## KA-01911 750S - Exterior Door Switch Inoperative

**Topic:** Door switch inoperative

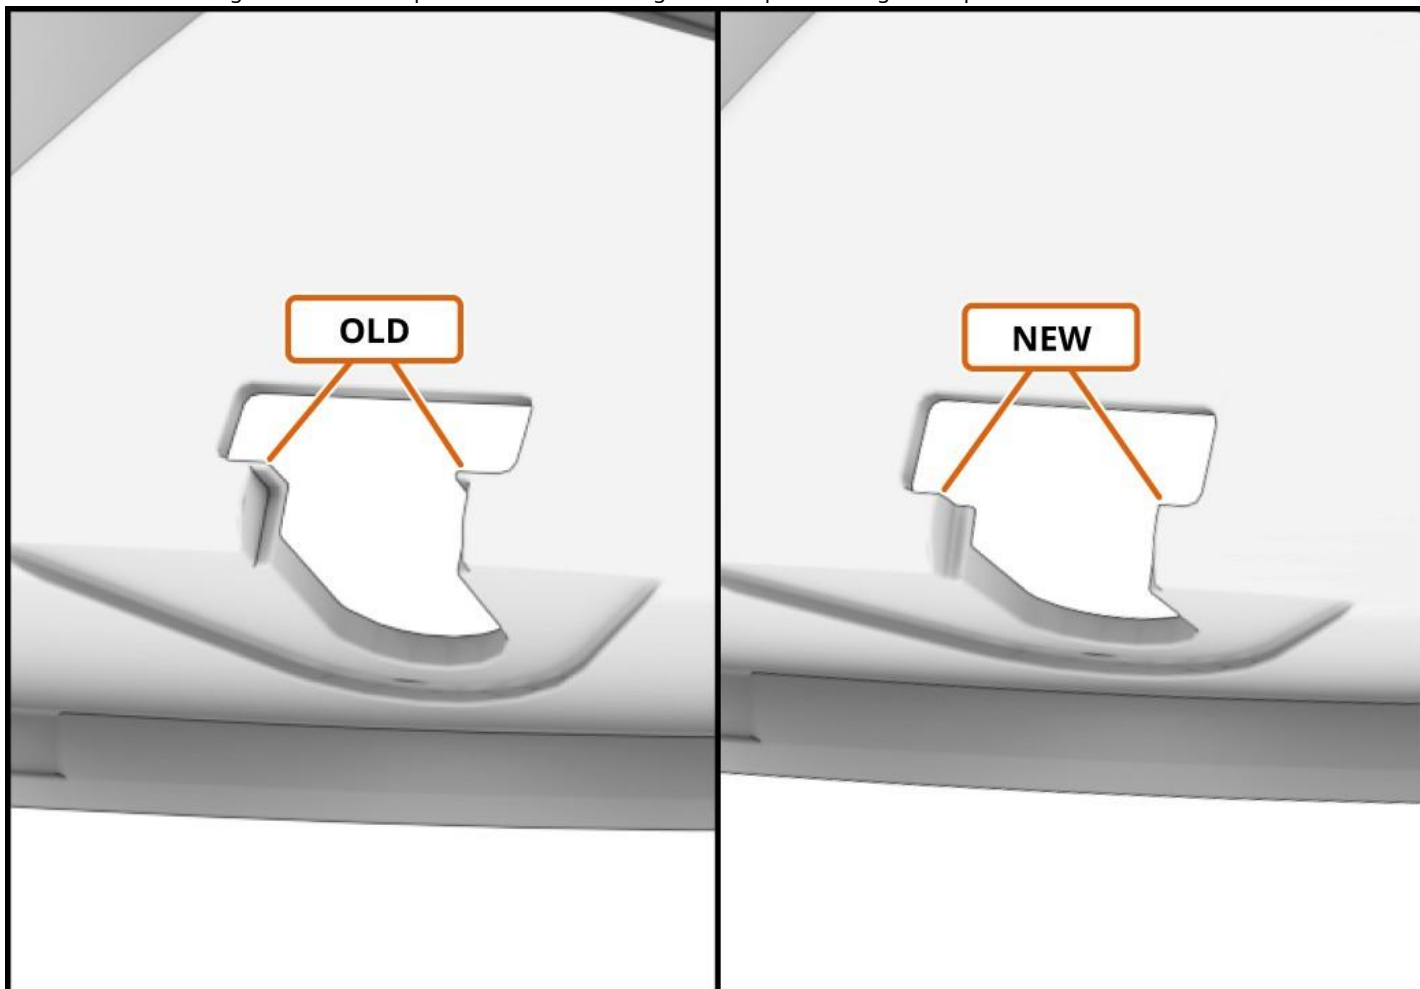
Through continuous product quality monitoring, McLaren have implemented a new door switch winglet component for McLaren 750S vehicles manufactured from 2025 onwards.

It has come to our attention that some 750S vehicles produced prior to this update may experience intermittent external door switch operation, under specific conditions. When exposed to high ambient temperature for extended periods, thermal expansion of the paddle material may prevent proper contact with the switch rendering it inoperative.

Please refer to the images below for comparison between the original and updated winglet components.

If you find this concern, please order replacement parts as per below parts information and reference MSP procedure – “Door Release Switch – External”.

28AB557CP - WINGLET DOOR OUTER LH

28AB558CP - WINGLET DOOR OUTER RH
